DOCKETED	
Docket Number:	24-OPT-03
Project Title:	Soda Mountain Solar
TN #:	265827
Document Title:	Jeff Aardahl Comments - Comments on Notice of Preparation of a Draft Environmental Impact Report for the Soda Mountain Solar Project
Description:	N/A
Filer:	System
Organization:	Jeff Aardahl
Submitter Role:	Public
Submission Date:	8/29/2025 12:52:55 PM
Docketed Date:	8/29/2025

Comments on Notice of Preparation of a Draft Environmental Impact Report for the Soda Mountain Solar Project

Re: Comments on Notice of Preparation of a Draft Environmental Impact Report for the Soda Mountain Solar Project

The 0.25 mile setback recommended by Dudek and the CDFW for the East Array is shown below:

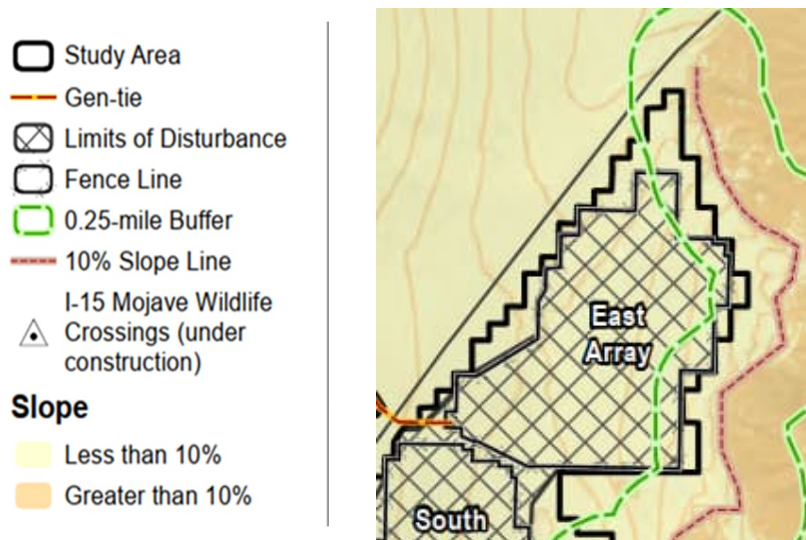
“Recommended New MM-BIO-23. Project Footprint Setback: Prior to project approval, the project will reconfigure the East Array alignment to stay outside of the 0.25-mile setback. This includes fencing and permanent infrastructure (e.g., roads). Smaller currently proposed encroachments may remain with the exception of the fencing intrusion between South Array 1 and South Array 2. Solar arrays lost during the reconfiguration of East Array may be added elsewhere so long as they do not additionally encroach upon the setback. This only applies to setbacks originating east of I-15.”

Comment: We are pleased that CEC staff will consider additional independent research and consult with the CDFW, USFWS and BLM when they consider developing additional impact mitigation measures. The CEC should not constrain consideration, analysis and adoption of a reduced project footprint simply because the applicant executed an Interconnection Agreement with LADWP for 300 MW. Reducing the footprint of the Project by 12% in the East Array is a relatively minor reduction.

In addition to the recommendation by Dudek and CDFW, we recommend that an additional alternative be developed and analyzed in the DEIR that reduces the Project footprint in South Arrays 2 and 3 to avoid intermountain habitat used by desert bighorn sheep (see Dudek’s maps ID 1723, ID 1834 and ID 1836).
